**COMMERCIAL BUILDING INSPECTION REPORT**

## PHASE 1 IMMEDIATE ACTION REPORT

Building Location: 100 W. Washington Ave., Jonesboro, AR

Building Located at 100 W. Washington in Jonesboro, Arkansas  
(Previously the Citizens Bank Building)

**Figure 1: Elevation Showing Wall Areas That Have Lost Substantial Lateral Support**

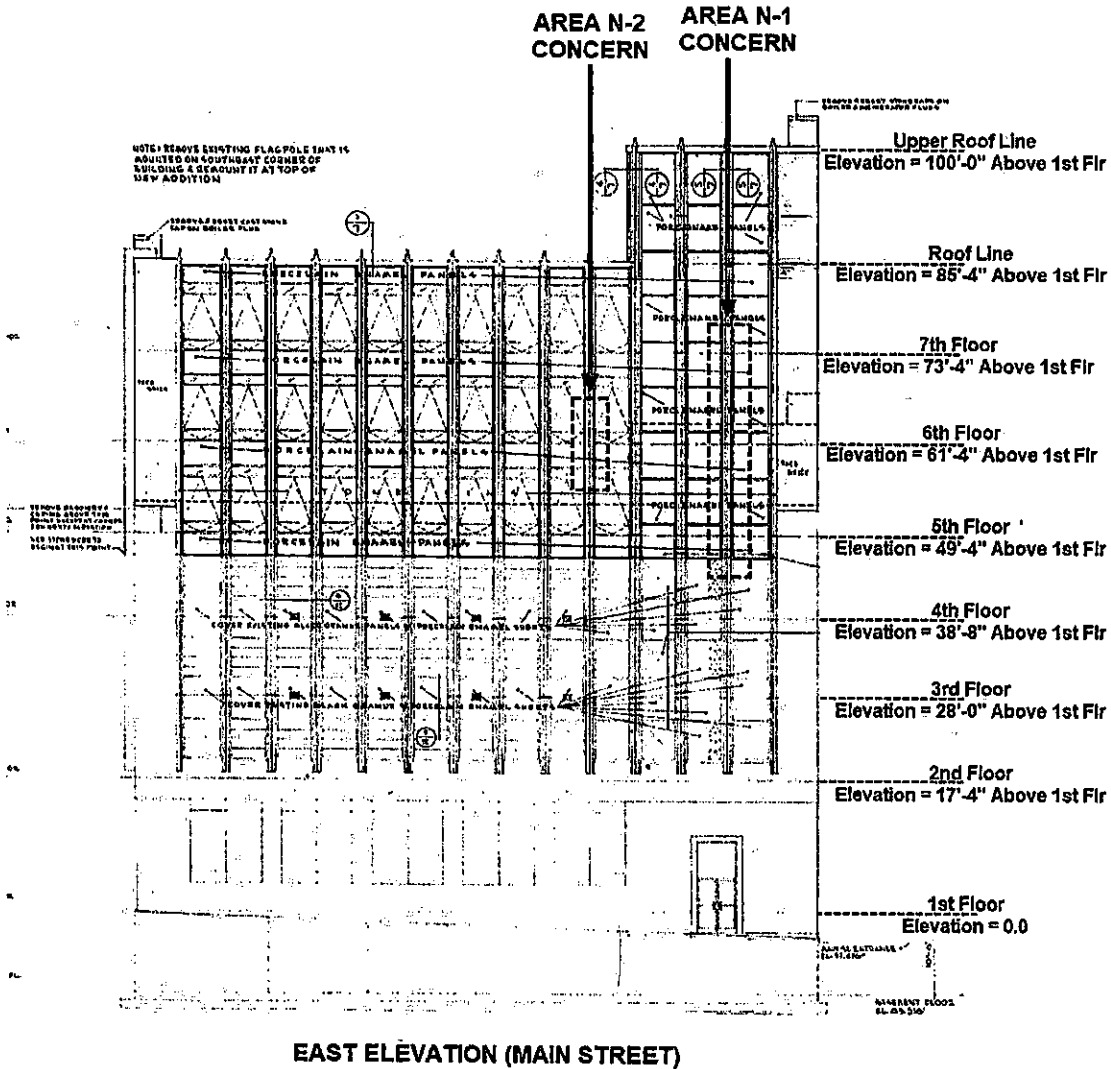
There are two areas where the exterior wall structure appears to have lost lateral support, and the wall structure has moved away from the building and is deflecting out to the east towards Main Street. See figure 1 and figure 2 below and photo 1 showing these areas. The wall structure area furthest north (between the stairwell and elevator structure) has moved the most and is the most concerning at this time. The area of concern for wall area N-1 is located between the 5th and 7th floor of the building between the stair structure and elevator structure. The area of concern for the wall area N-2 is more isolated and occurs above and below the 6th floor level.

Wall area N-1 is deflecting outward (towards the east) several inches and appears to be at risk of collapse. The lateral ties from the steel beams to the vertical precast elements at area N-1 have been compromised and appears to have lost support for at least a twenty foot vertical length near the 6<sup>th</sup> floor level. Area N-2 is also deflecting outward (towards the east) several inches but does not appear to be as concerning as wall area N-1 at this time.

After the scaffolding and wood protection wall is constructed, it is recommended to add lateral bracing to the vertical precast concrete elements at area N-1 and N-2. This should be done before any other work or demolition begins on the structure. The lateral bracing should be made to area N-1 near the 5th and 6th and 7th floor levels and can be extended into the building and anchored to the concrete floor slab or some other solid structure. The lateral brace can be in the form of steel angles to grab the vertical precast concrete elements and stabilize them and possibly even pull them back into the building slightly. A licensed contractor should be engaged to add the lateral bracing to areas N-1 and N-2 before any façade removal begins.

**Figure 3: Aerial View Showing Recommended 2x6 Wood Protection Wall Location**

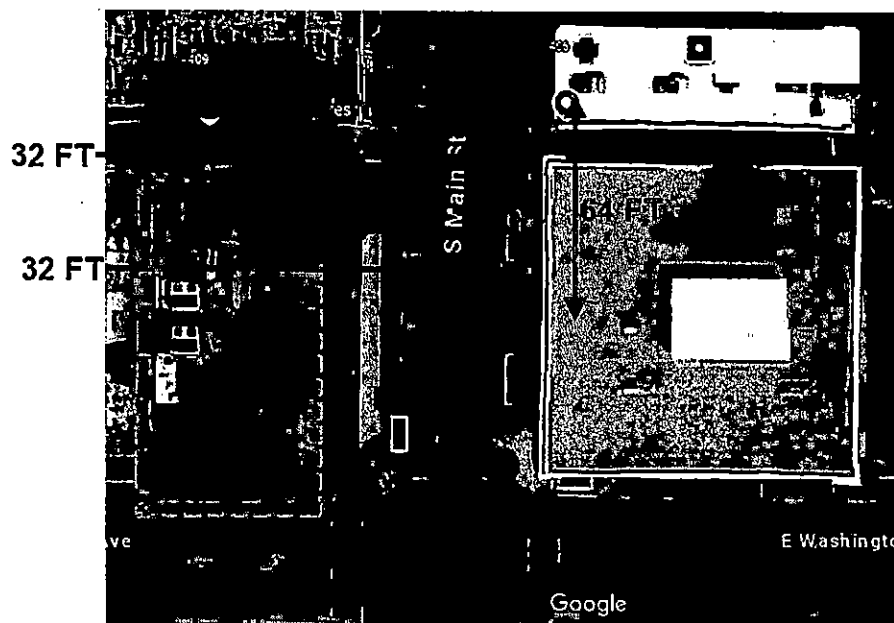
Due to the risk of the vertical architectural precast concrete elements collapsing and falling away from the old Citizens Bank building, a protection wall is recommended to be constructed on the west side of the First Horizon building (located at 420 S Main Street) and on the west side of the Mutual of Omaha building (located at 408 S Main Street). The wall is recommended to be approximately 64 feet long and 16 feet tall to potentially protect any falling debris from entering or damaging the occupied these

two buildings. See figure 3 below for the recommended wall layout. The wall can be constructed approximately 32 feet north and 32 feet south of the unstable vertical precast at area N-1.

The wall is recommended to be constructed using steel scaffolding with 2x6 wood studs at 16-inches on center and attached to the scaffolding structure. The 2x6 wood stud wall should have 1 layer of 3/4-inch plywood nailed to each face of the wood studs. A lower diagonal 2x6 wood stud brace at 32-inches on center can be added at the bottom of the wall for additional lateral strength. A typical detail of the scaffolding and wood stud wall can be provided as needed.
